New Regulation on Enhanced Child Restraint systems

Proposal for Supplement 2 to Regulation [129] (Enhanced Child Restraint Systems (ECRS))

Submitted by the expert from France*

Paragraph 4.5., the figure, amend to read:

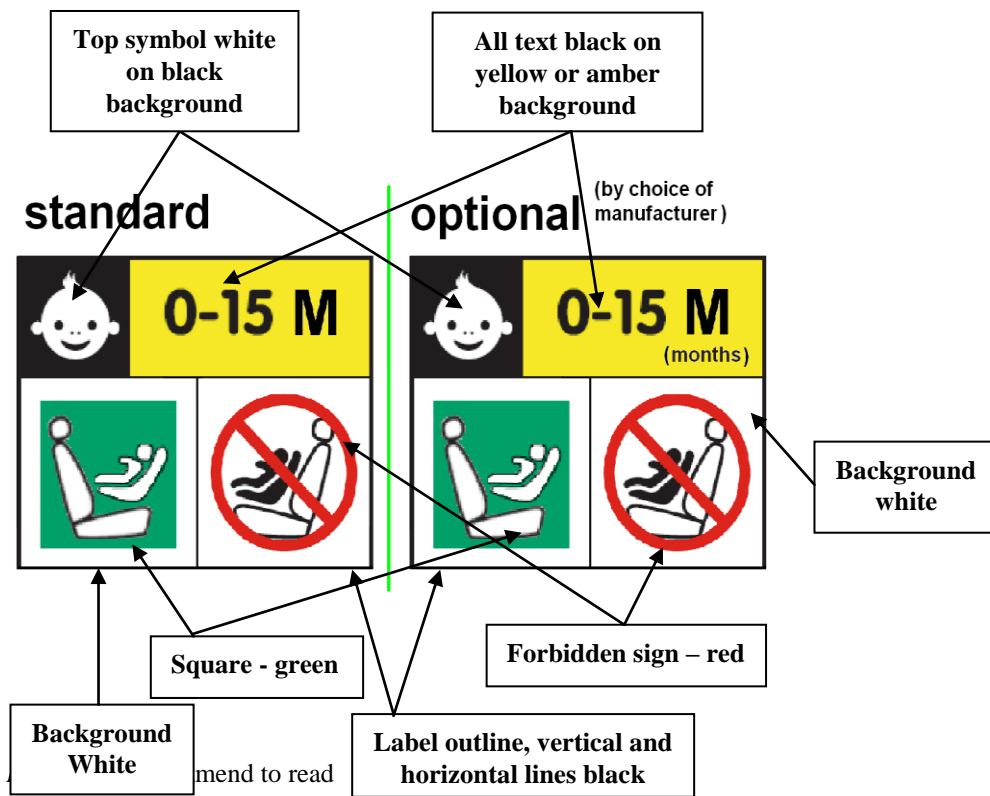
"4.5. In the case of...
Minimum label size 40 x 40 mm

Figure 3

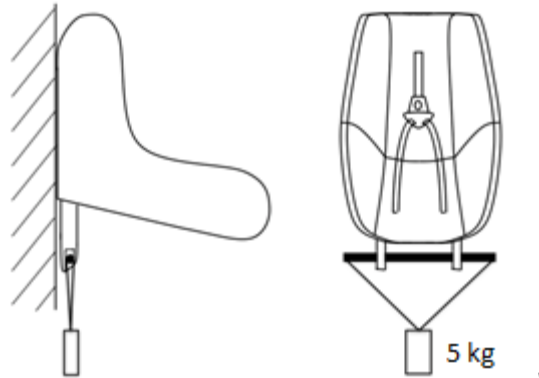
- 7.2.8. The complete seat, or the component fitted with ISOFIX attachments (e.g. ISOFIX base) if it has a release button, is attached rigidly to a test rig in such a way that ISOFIX connectors are vertically aligned as shown in Figure 3. A 6 mm diameter bar, 350 mm long, shall be attached to the ISOFIX connectors. A mass of 5 kg shall be attached to the extremities of the bar.**

Arrangements of the approval mark

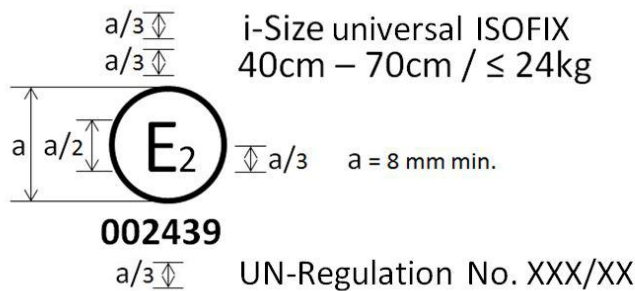
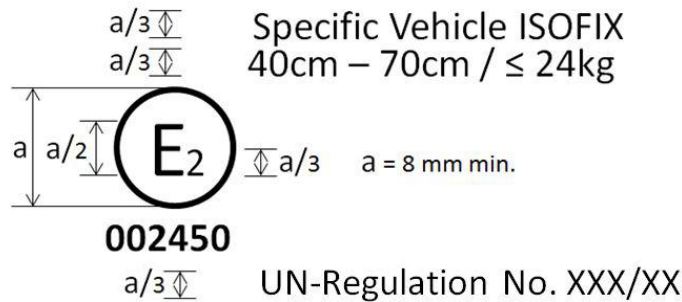
The child restraint system bearing the above approval mark is a device capable of being fitted in any i-size compatible vehicle **seating position** and of being used for the 40 cm to 70 cm size range and mass limit of 24 kg; it is approved in France (E2) under the number ~~00xxx~~ **002439**. The approval number indicates that the approval was granted in accordance with the requirements of the Regulation concerning the approval of enhanced Child Restraint Systems used onboard of motor vehicles as amended by the 00 series of amendments. **In addition the name of the regulation has to be identified on the approval mark followed by the series of amendment according to which the approval has been granted.**

The child restraint system bearing the above approval mark is a device not capable of being fitted in every vehicle and of being used for the 40 cm to 70 cm size range and mass limit of 24 kg; it is approved in France (E2) under the number 002450. The approval number indicates that the approval was granted in accordance with the requirements of the Regulation concerning the approval of specific vehicle ISOFIX child restraint systems used on board of motor vehicles as amended by the 00 series of amendments. **In addition, the name of the regulation has to be identified on the approval mark followed by the series of amendment according to which the approval has been granted.**

"Figure 1

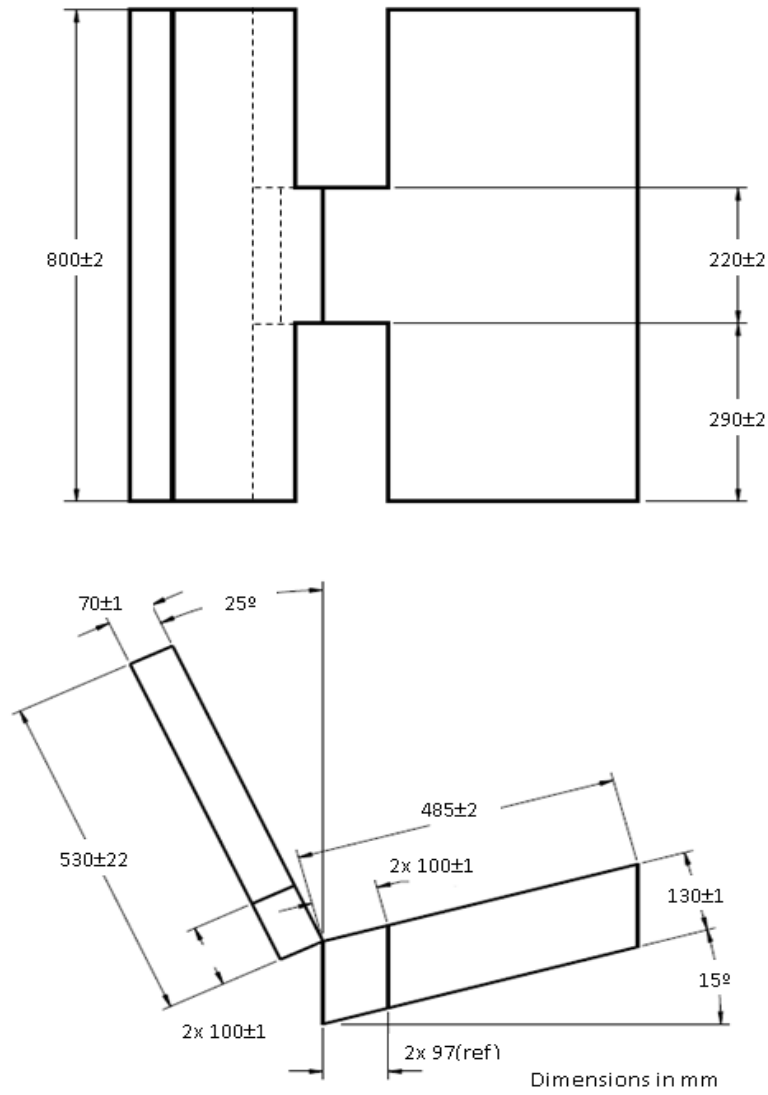
Figures 1 and 2, amend to read:

"Figure 3
Dimensions of the cover material (dimensions in mm)

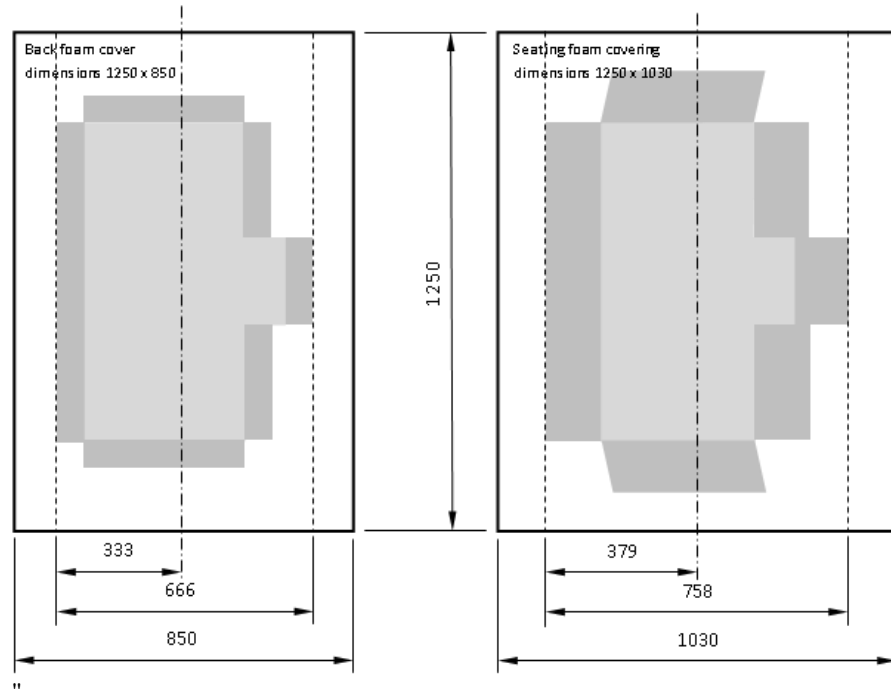
Figure 4(former), renumber as figure 3 and amend to read:

Figure 3
Side view of the support leg foot assessment volume

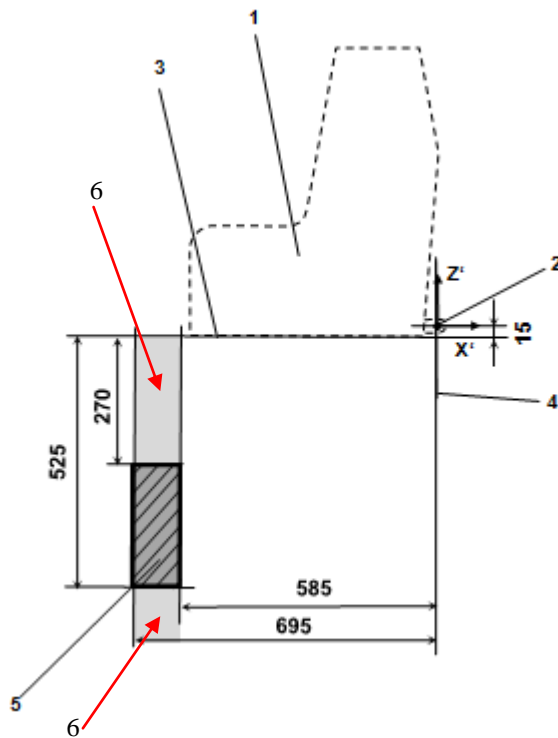
It shall be permissible for the support-leg to be adjustable beyond the height limits in the **Z'** direction (**as indicated by key 6 in figure 3 of Annex 19**), providing that no parts extend beyond the limiting planes in the **X'** and **Y'** directions.

Load application device I (to be used for Q0, Q1, Q1.5 dummies)

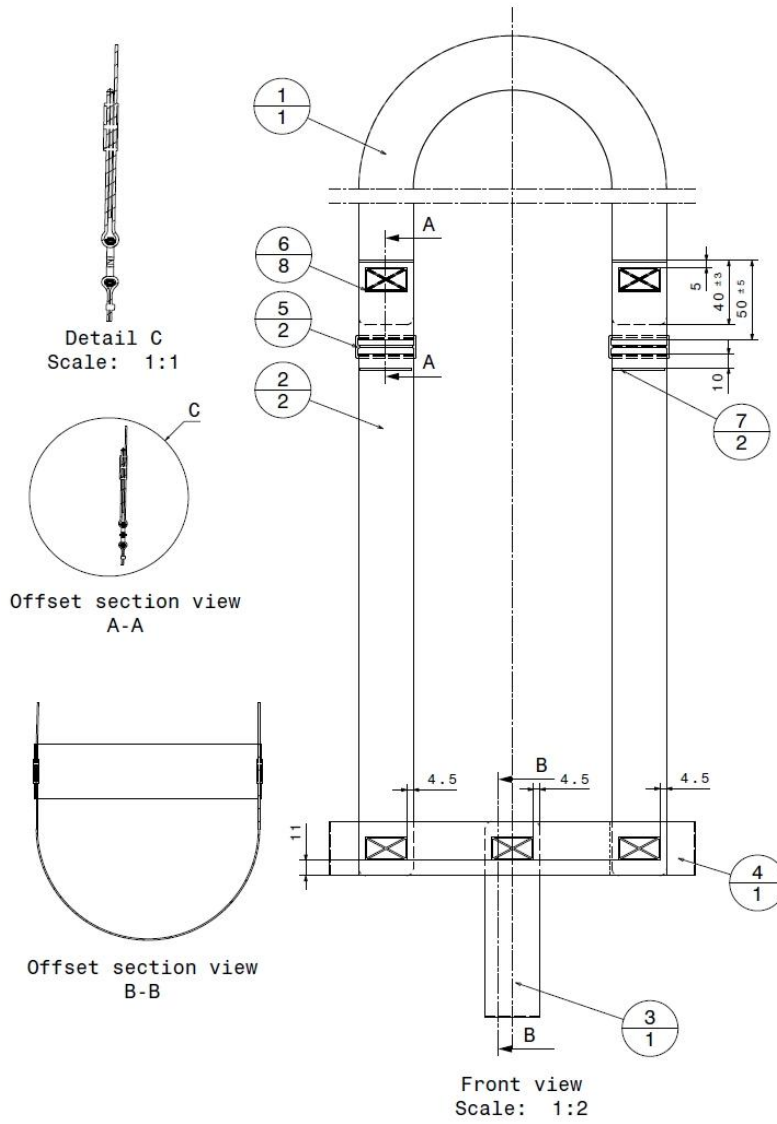
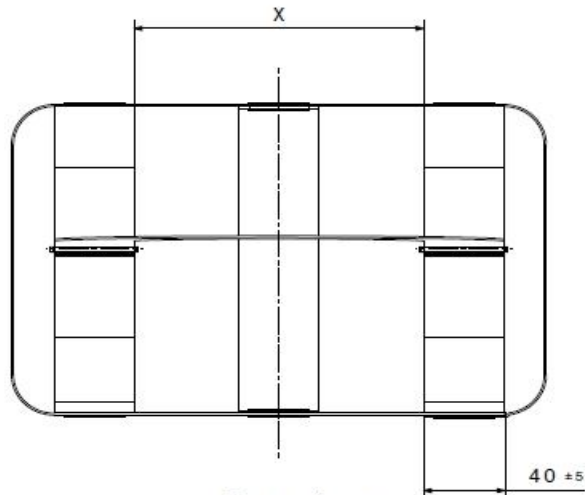
- "7.1.2.3. **At this static inverted position, a mass equivalent to four times that of the dummy shall be applied vertically downwards in a plane perpendicular to the axis of rotation in addition to the dummy utilizing the load application device described in Annex 21. The load shall be applied in a gradual controlled manner at a rate not exceeding gravitational acceleration or 400mm/min. Maintain the prescribed maximum load for a duration of 30 -0/+5 seconds.**
- 7.1.2.4. **Remove the load at a rate not exceeding 400 mm/min and measure displacement.**
- 7.1.2.5. **Rotate the whole seat for 180° to return to the starting position."**

Insert new Annex 21, to read:
